Planning Application under Section 16 of the Town Planning Ordinance for Proposed Residential Institution (Student Hostel) at Middleton Towers, 140 Pokfulam Road (RBL No. 825 RP) (Application No. A/H10/98)
Submission of Responses to Comments (1st Batch)

Annex A Response to Departmental Comments

**S.16 Planning Application for Proposed Residential Institution (Student Hostel) in “Residential (Group C)”
with a minor portion within “Green Belt” Zones at Middleton Towers, 140 Pok Fu Lam Road (Rural Building Lot No. 825 RP)
and adjoining Government Land, Pok Fu Lam, Hong Kong**

Annex I Approved Building Plan

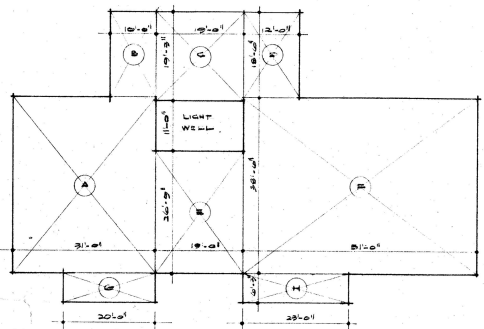
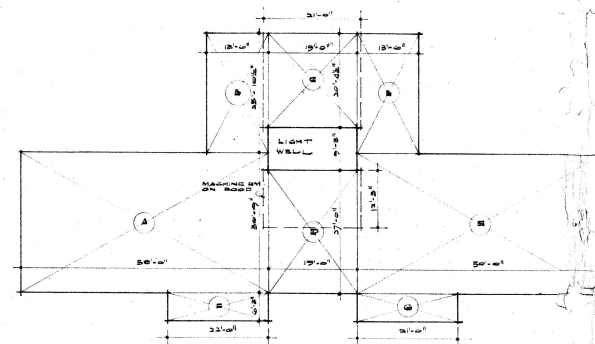
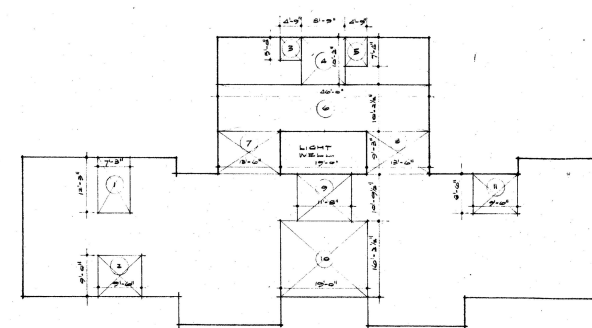
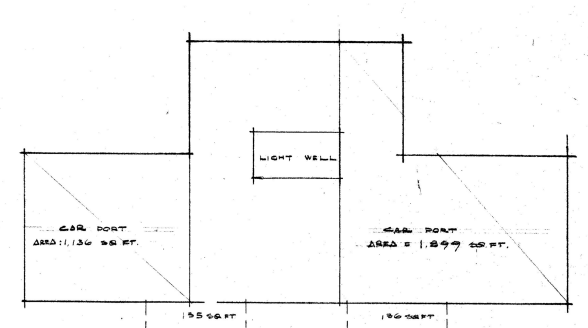
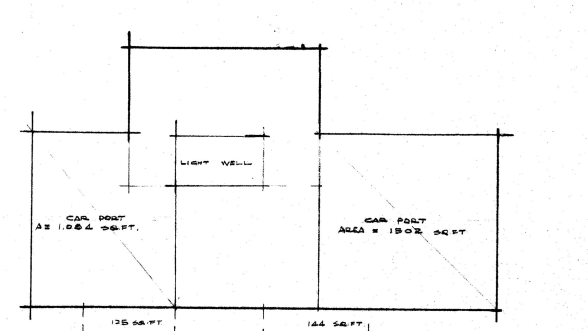
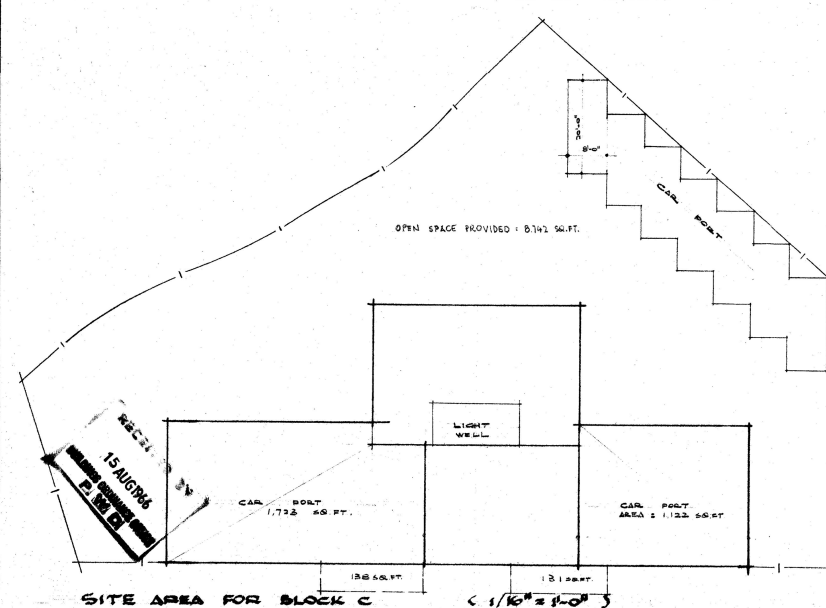
1.1.	I have no objection in principle under the Buildings Ordinance to the s.16 application. Please note that the proposal involves slabbing-over of light wells; thus, additional plot ratio and site coverage will be resulted. Detailed comments will be made at building plan submission stage.	Noted.

Item	Comments Received	Responses
		area and gross floor area as stipulated in the GBP record above, via building plan to be submitted to the Buildings Department for approval prior to works commencement. For the area calculations stipulated in the approved GBP and layouts of existing 1-storey covered carports, please refer to Annex I and Annex II respectively for information.
